SECTION 4.15 EVALUATIONEnvironmental Planning and Assessment Act 1979 (as amended)

Development Application No.	DA007/24 PAN 403740
Subject Site	Lot 7 DP263999 1A Caroline Avenue Bowenfels
Proposal	Detached Garage (and removal of existing garage)
Zoning	R1 General Residential
Permissibility	Residential garage ancillary to the existing dwelling is permissible
Cost of Development	\$61,801.00
Applicant	Fernleigh Drafting
Owner	Phillip Peace
Notification	The proposal was neighbour notified in accordance with the Lithgow Community Participation Plan 2020.
Submissions	<ul style="list-style-type: none">• Original proposal – Neighbour notified. A petition with twelve (12) signatures was submitted from surrounding residents in support of the proposed development. No objections were received from the community.• Amended proposal of 6 February 2025 neighbour notified with no objections received from the community.
Affiliations and Pecuniary Interests	There are no affiliations or pecuniary interests declared by the applicant

Potential Reportable Donations/Gifts	NIL
Variations sought	Lithgow Development Control Plan 2021 (DCP): <u>Part 6.4.7</u> <ul style="list-style-type: none">• Maximum floo

Fig 3: Site plan

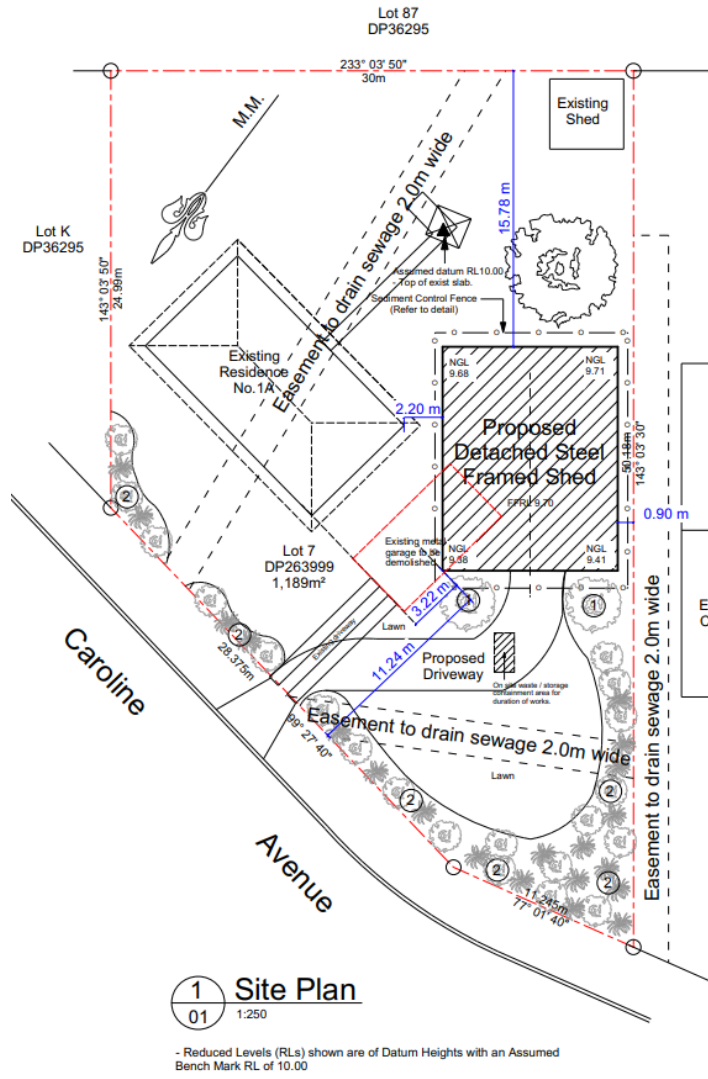
- The proposed 128m² garage / shed exceeds the maximum permissible floor area of 100m² under the DCP (exceeded by 28m²)
- The proposed 900mm side boundary setback does not comply with the required minimum 1.2m setback (applicable to a maximum permissible 3m wall height) as outlined in the DCP
- The proposed wall height of 4.2m exceeds the maximum permissible wall height of 3m detailed in the DCP by 1.2m.
- The proposed ridge height of 5.172m exceeds that maximum permissible 4.5m requirement under the DCP by 0.672m.

- The proposed access and driveway are not suitable for a large motor home vehicle.
- The proposed driveway does not provide sufficient room to maneuver the subject motor home vehicle to enter or exit the proposed garage without using the grassed area and without traversing over Council’s Sewer Easement.
- The owner of the property has provided video evidence demonstrating that the motor home vehicle has sufficient space to manoeuvre onsite to enter / exit the site in a forward direction, albeit with a swept path that traverses Council’s Sewer Easement.

Fig 4: Front elevation of proposed Garage

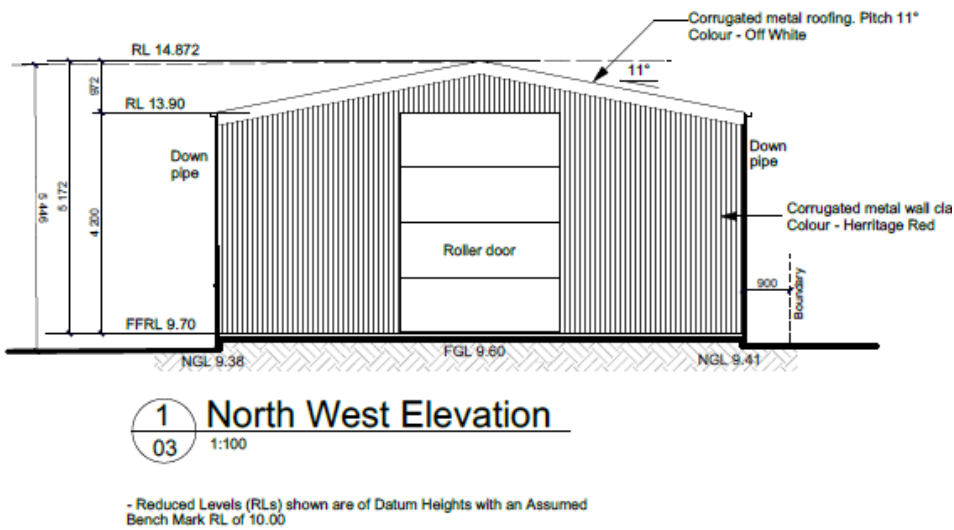
The photos below (see Fig 6) show the height of the motor home vehicle in relation to the existing dwellings. The proposed roller door on the front elevation and front wall height (4.2) will be higher than the height of the motor home vehicle and the top of the opening will be higher than the wall and portion of the roof height of the dwellings.

<p>Maximum Wall height – NON-COMPLIANCE</p> <p>DCP control – 3m</p> <p>Proposed: 4.2m (exceeds DCP control by 1.2m)</p> <p>Applicant’s reasons for variation</p> <p>The increase in the wall and ridge height is required to store a bus within the proposed garage and not in the front yard.</p> <p>Maximum ridge height – NON-COMPLIANCE</p> <p>DCP control -4.5m</p> <p>Proposed: 5.172m (exceeds DCP control by 672mm)</p> <p>Applicant’s reasons for variation</p> <p>The increase in the wall and ridge height is required to garage a motor home vehicle within the proposed garage and to provide a sufficiently sized roller door opening.</p>
<p>10. Setbacks for Parking – all enclosed car parking areas have the opening/garage door setbacks a minimum of 5.5m from the front lot boundary of the street they connect to (rear lanes may have reduced setbacks depending on the desired character of the lane) to enable a single vehicle to be parked in the driveway entirely on the lot without interfering with the public domain/footpath and to avoid dominating the street.</p>	<p>COMPLIANCE</p>
